**Response to Design
Conditions of Consent**
THE TIMBERYARDS BY RTL CO.

Response to Design Conditions of Consent

Consent Condition B1

Consent Condition B2

Building D

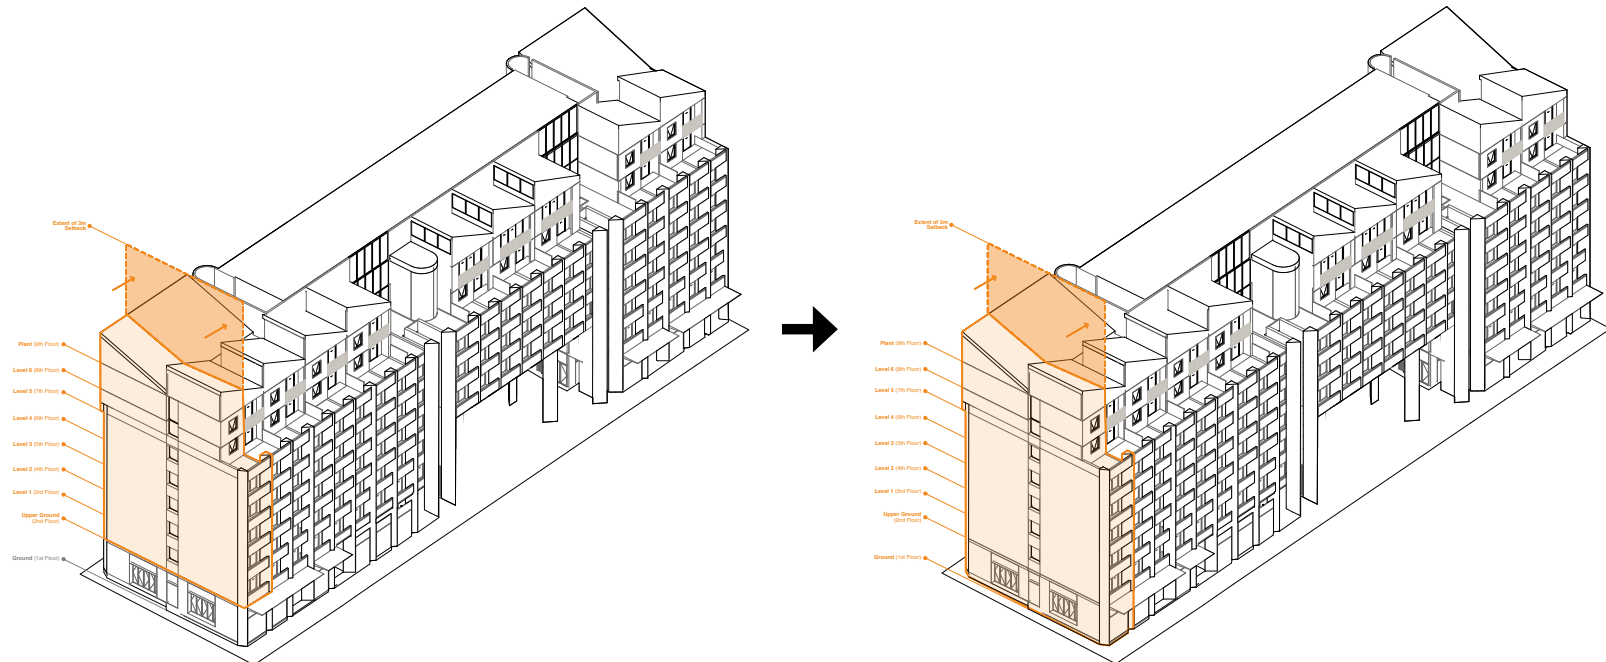
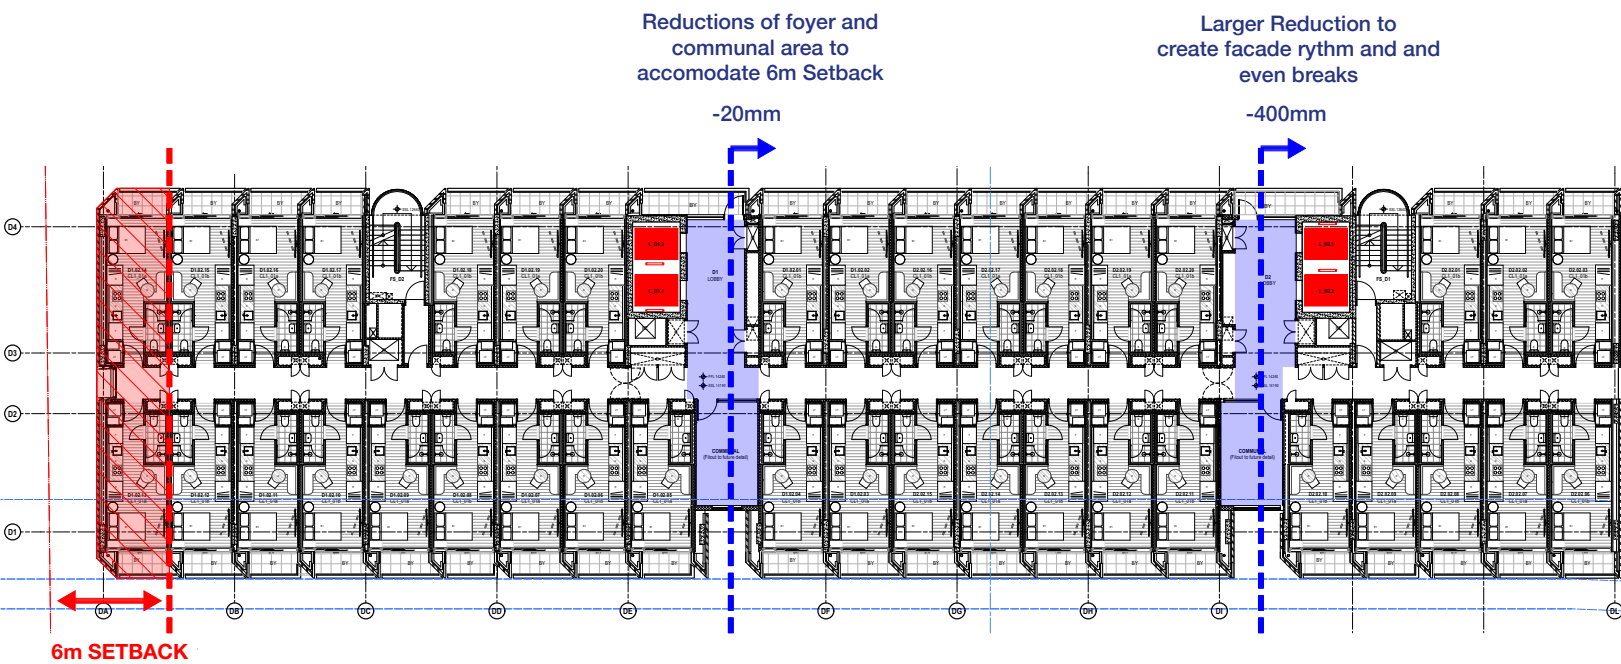
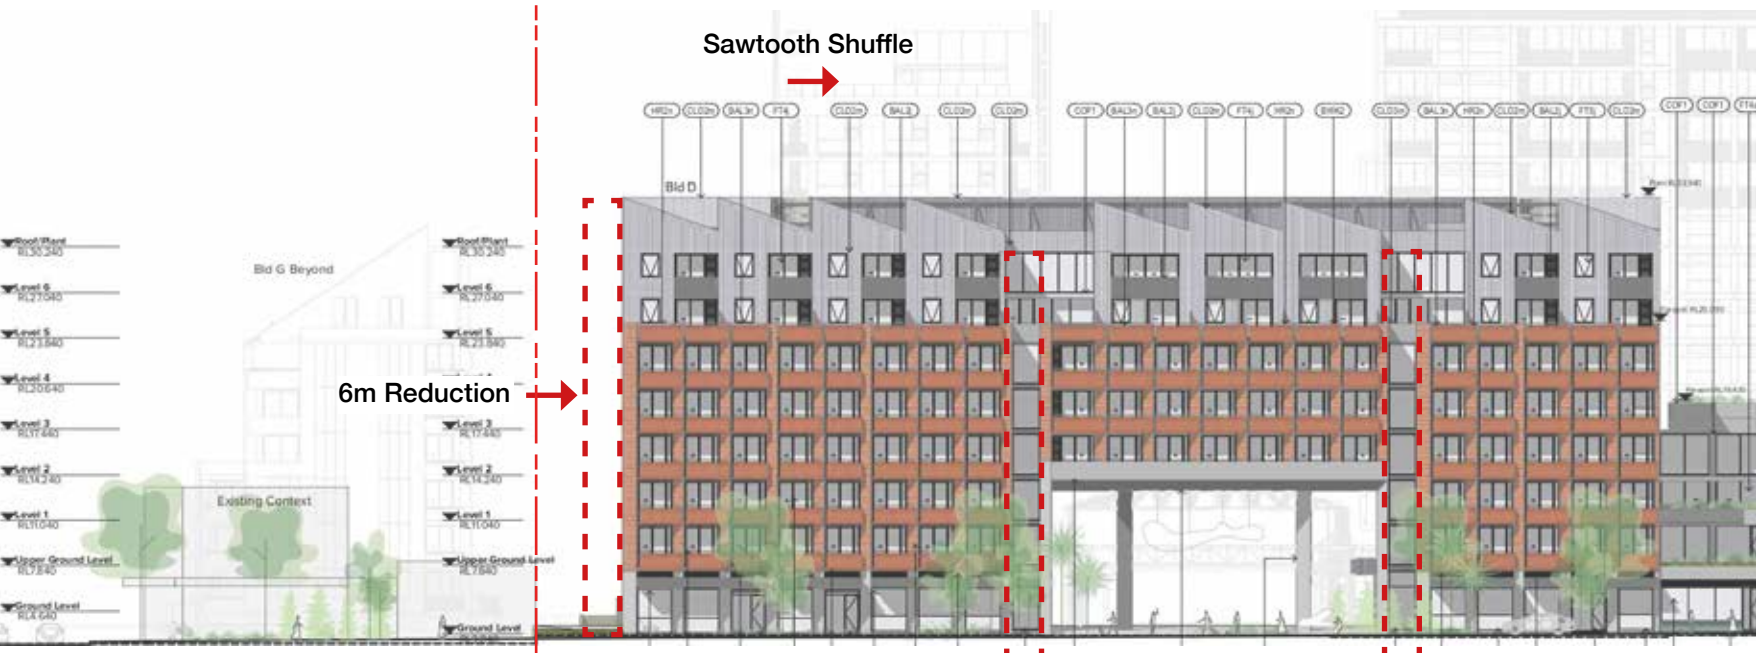
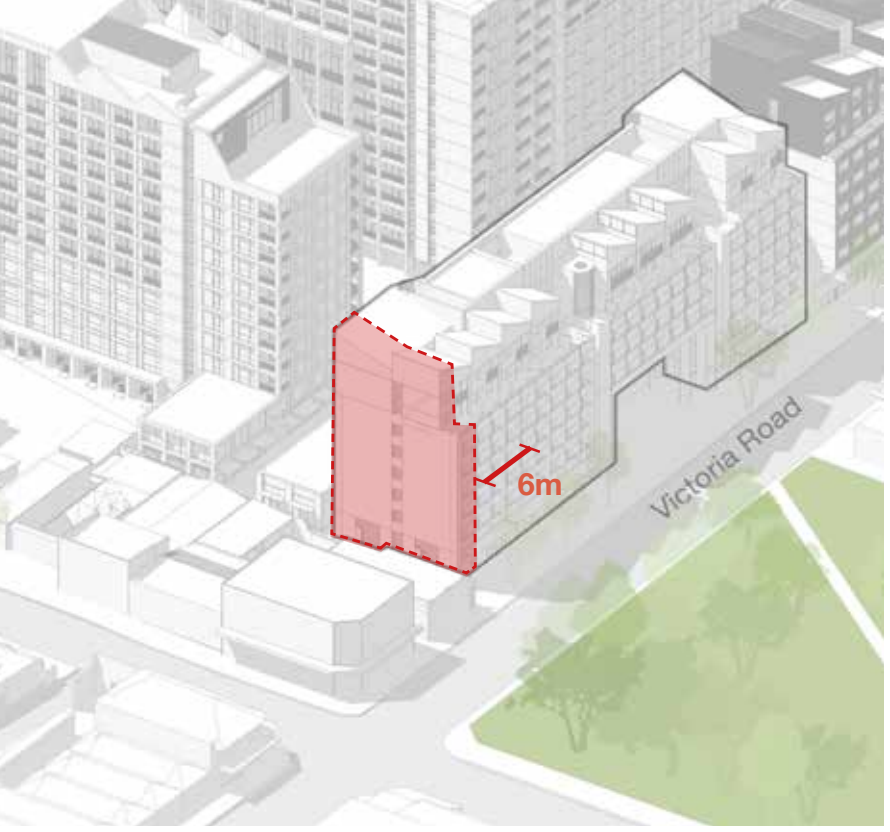
(a) a minimum boundary setback of 3 metres at the ground floor level of building D to the adjoining property at 199 Victoria Road; and

(b) a minimum boundary setback of 6 metres for levels 1 and above of building D to the adjoining property at 199 Victoria Road.

Condition of Consent B1 required the side setback between the south-western façade of Building D and the neighbouring boundary to be increased to 3m at ground level, and 6m above this. We propose to continue the upper level 6m setback to ground, increasing the width of the new laneway established between Building D and the neighbouring boundary (Wicks Alley). This offers a more generous public realm, with greater opportunities for planting and for outdoor dining from adjacent tenancies, while providing a more resolved and intentional architectural form.

The building is set back and expressed architecturally as metal clad sawtooth roofs, referencing the form of historic Marrickville warehouses. To retain the formal integrity of the proposal established by this key design element, while providing a 6m Setback, the previously approved sawtooth volumes have been shifted north-east, away from the neighbouring boundary. As a result, an external feature stair connecting levels 5 and 6 has been removed to minimise any loss of communal open space at level 5.

Building G

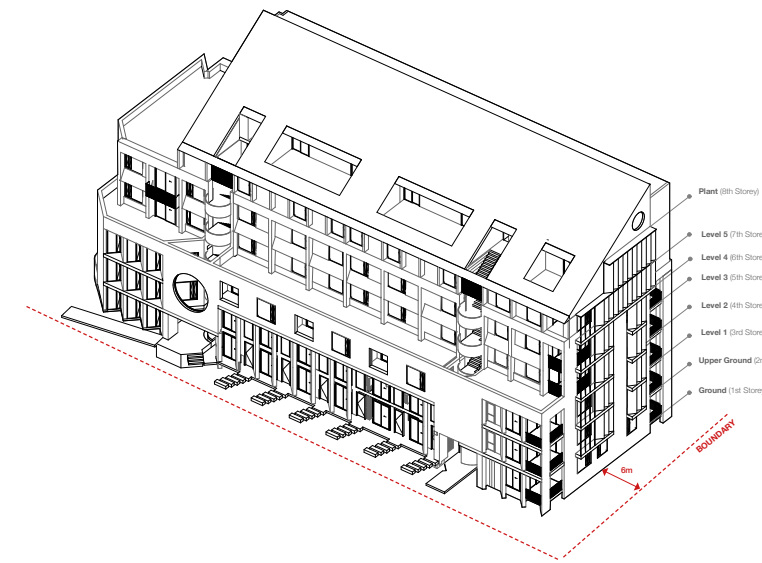
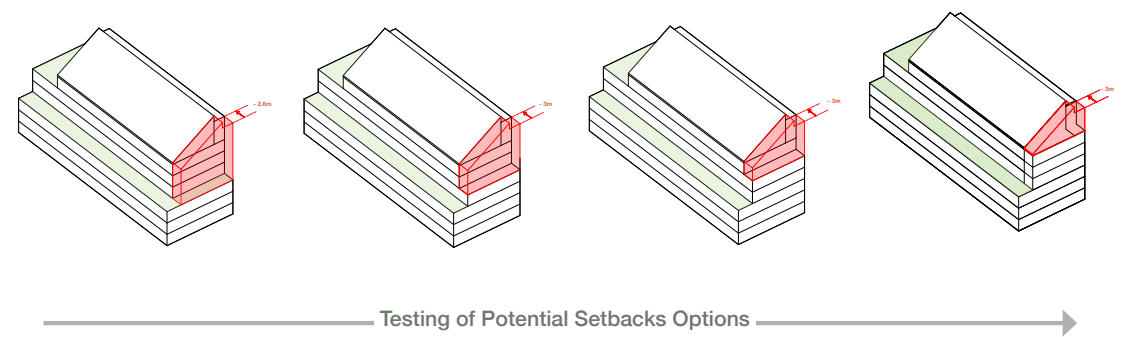
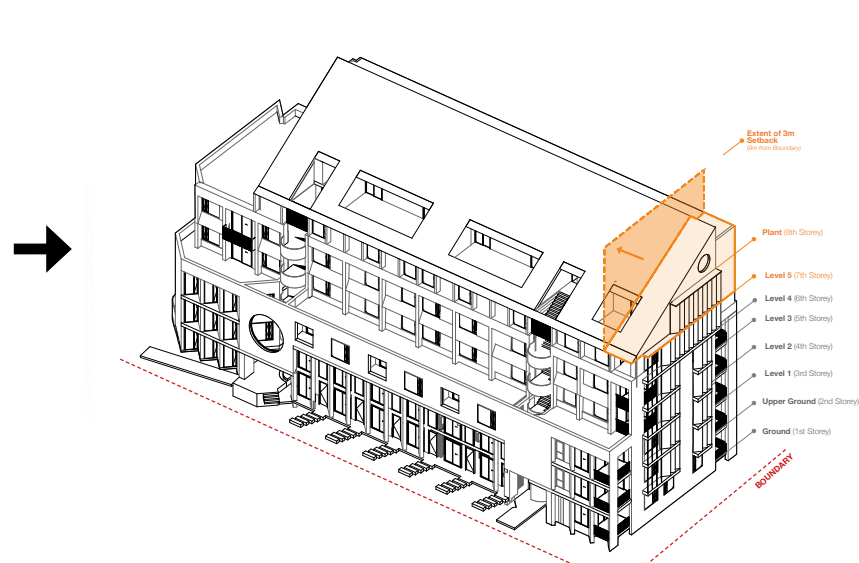
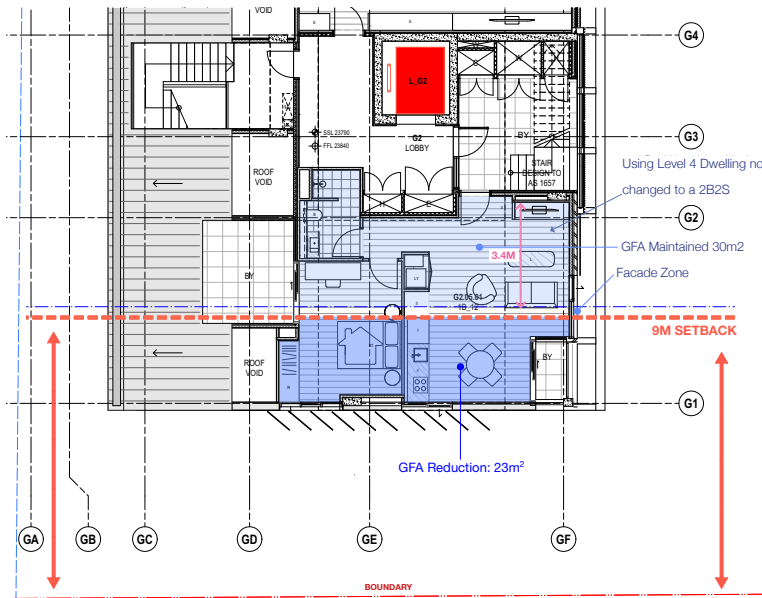
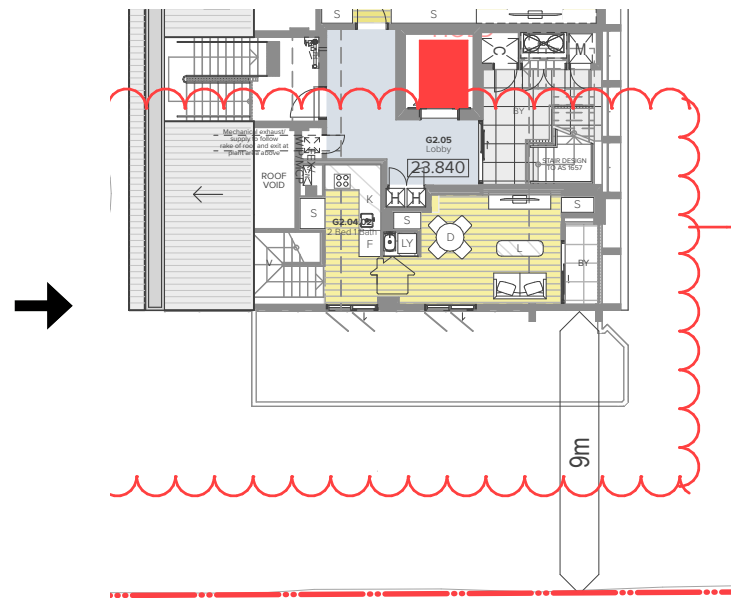
Prior to the issue of CC7, the Applicant must provide evidence to the Certifier that the revised plans detailing the following revisions have been submitted to and approved by the Planning Secretary:
(a) a minimum boundary setback of 9 metres for levels 5 to 7 of building G to the adjoining property at 119 Sydenham Road.

The Department's recommended condition requiring a further 3-metre setback on levels five to seven of Building G provides additional separation to 119 Sydenham Road for improved amenity and privacy outcomes to the neighbouring corner site. The removal of this mass from the building has an impact on internal plan arrangement, structural design and subsequent elevational expression. It also has an impact on building proportion and symmetry. Internal plan layouts on Levels 04 and 05 have been redesigned to accommodate the change, and elevations adjusted.

In addition to this impact, the change of bulk, height and scale at the Eastern end of the building is managed through careful manipulation of material language. The proportion and massing have been finessed through the introduction of off-form concrete blades, which enhance the verticality of the mass. To integrate and manage the new proportions and composition, we have treated both ends as individual pieces of expression. The ends of the building are stripped of their brick cladding and expressed as off-form concrete. The concrete blades have a vertical predisposition, which is juxtaposed against the strong horizontality of the brickwork in the centre of the building.
